#### City of Portland, Maine - Building or Use Permit Application 389 Congress Street, 04101, Tel: (207) 874-8703, FAX: 874-8716 Location of Construction: Owner: Phone: Permit No: 980701 1327 Westbrook St McDonaugh, John Owner Address: Lessee/Buyer's Name: BusinessName: Phone: SAA Permit Issued: Contractor Name: Address: Phone: Quality Design 17 Kelly Rd Falmouth, ME 04105 781-5405 JUL - 2 1998 COST OF WORK: PERMIT FEE: Past Use: Proposed Use: 6,000.00 50.00 FIRE DEPT. □ Approved INSPECTION: 1-fam Use Group: Type: ☐ Denied Zone: CBL: 218-C-006 Signature: Signature: Zoning Approval: Proposed Project Description: PEDESTRIAN ACTIVITIES DISTRICT (P.A.D.) Action: Approved Special Zone or Reviews Approved with Conditions: ☐ Shoreland ■ Construct Deck (12 x 43) Denied □Wetland ☐ Flood Zone ☐ Subdivision Signature: Date: ☐ Site Plan mai ☐minor ☐mm ☐ Permit Taken By: Date Applied For: SP 30 June 1998 **Zoning Appeal** □ Variance This permit application does not preclude the Applicant(s) from meeting applicable State and Federal rules. ☐ Miscellaneous Building permits do not include plumbing, septic or electrical work. □ Conditional Use Building permits are void if work is not started within

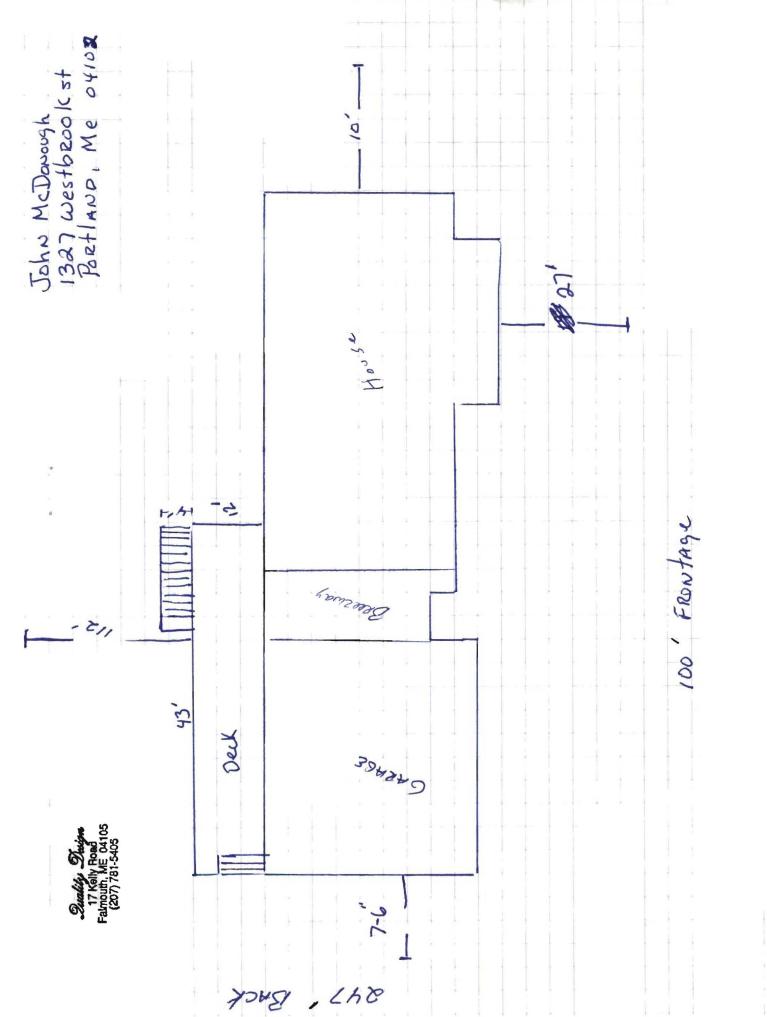
<b>28</b> .	Please read and implement the attached Land Use-Zoning report requirements.
<del>X</del> 29.	Sono Tubes shall be placed on Footings 4 below grade with
. ,	anchor Connection The Two (FOCTING Tube)
<b>3</b> 0.	The Dono Tube and Columns Shall be connected with Tie.
	FastBarry Connection).
31.	Deck Lug bolted to house sill. , Eastoner
	[Y]
32.	1 Tube
	F00T179
	<u> </u>
